**STAFF RECOMMENDATION**

**1724 5<sup>th</sup> Avenue North**

**June 17, 2020**

**Application:** New Construction—Addition; Setback determination; Partial Demolition

Figure 3. The window that will be added to the right façade.

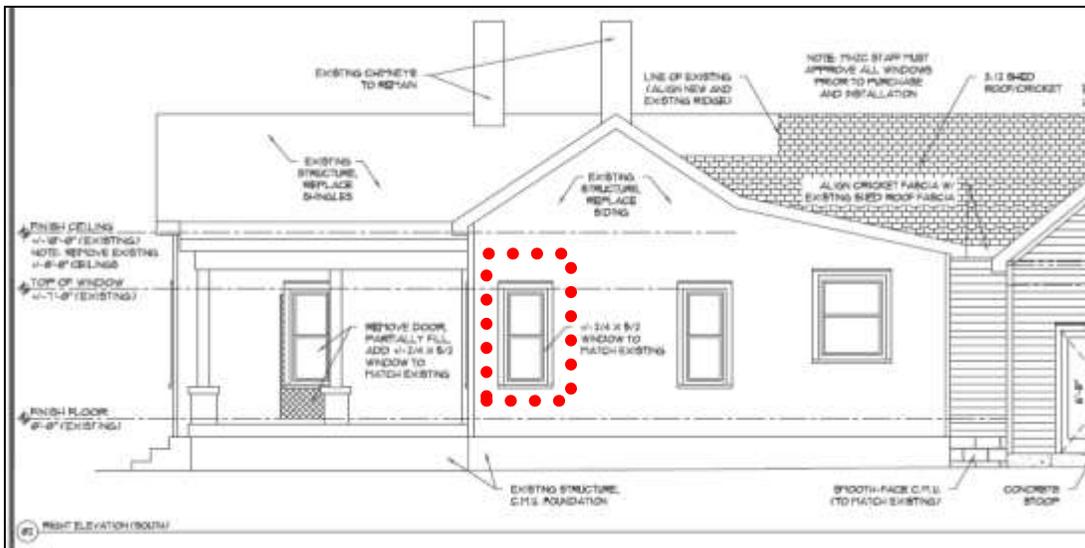
On the right façade, the applicant seeks to add a window opening, towards the front (Figure 3). Staff finds this to be appropriate because it is a location where a window could have been historically and the addition of the window does not detrimentally affect the historic character of the house.

Figure 4. The proposed change to the window opening on the left façade.

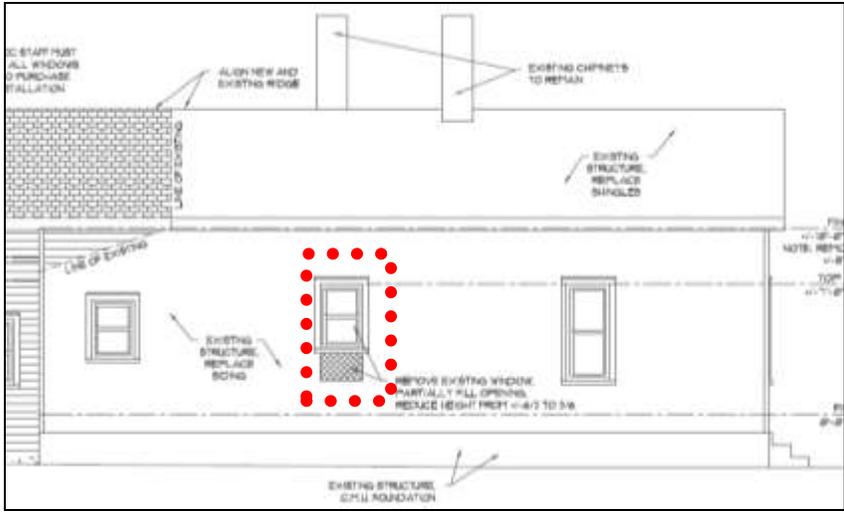
On the left façade, one window opening at about the midpoint of the house will be shortened (Figure 4). Staff finds this to be appropriate because the window opening will remain and will be vertically oriented and because this it not towards the front of the historic house.

Figure 5 (left) is the 1957 Sanborn map showing the original footprint of the house. Figure 6 (right) shows the existing extent of the house, with the post 1957 addition circled.

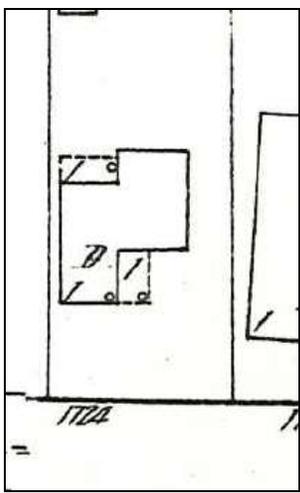
The applicant also intends to alter the roof forms of the rear section of the house. Most of these areas are additions constructed after 1957 (Figures 5 & 6). The former rear porch on the left side is original, but MHZC has regularly allowed such former porches to be removed and/or altered since they were often not built to last over hundred years and are not highly visible from the street. Staff finds that the removal and reconfiguration of these rear parts of the house are appropriate demolition that meets the design guidelines.

02 SITE PLAN Scale: 1/8" = 1'-0"

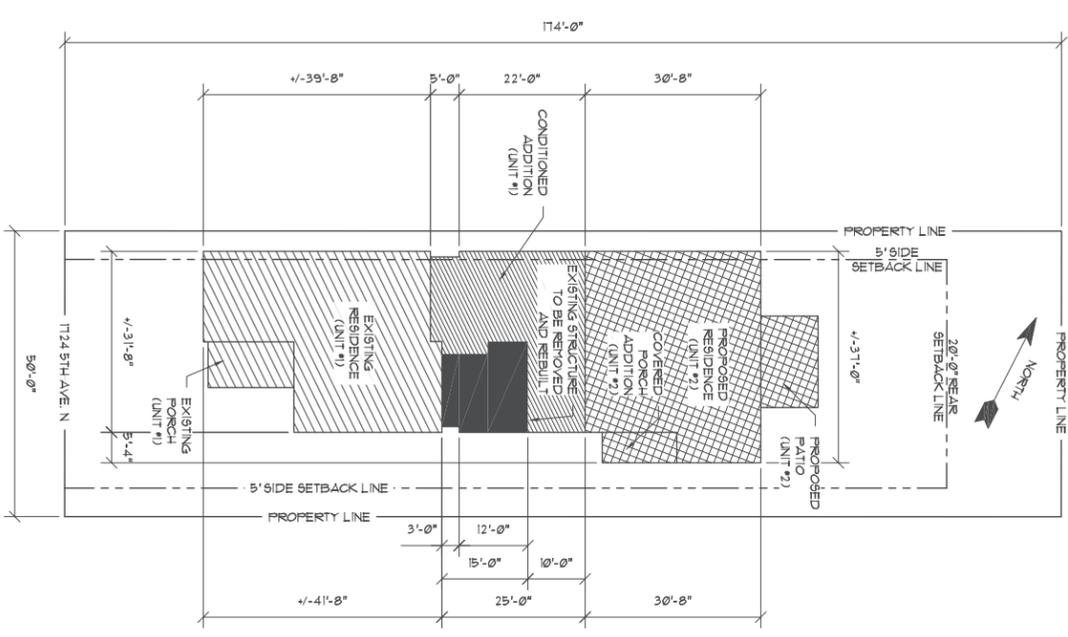
Setback & Rhythm of Spacing: The existing house does not meet the five foot (5') setback on the left side. The existing house is just three feet, six inches (3'6") from the left side property line. The addition, after the inset, will line back up to match the side wall of the house on the left side, and therefore the addition will also be just three feet, six inches (3'6") from the side property line. The addition requires a setback determination on the left side. Staff finds that the proposed left side setback and the setback determination to be appropriate because the addition is no wider than the historic house.

The right side of the addition will be about ten feet (10') from the side property line, and the rear of the addition will be about fifty feet (50') from the rear property line, both of which meet the design guidelines.

Staff finds that the proposed setbacks, including the setback determination, meet Section III.C. and IV. of the design guidelines.
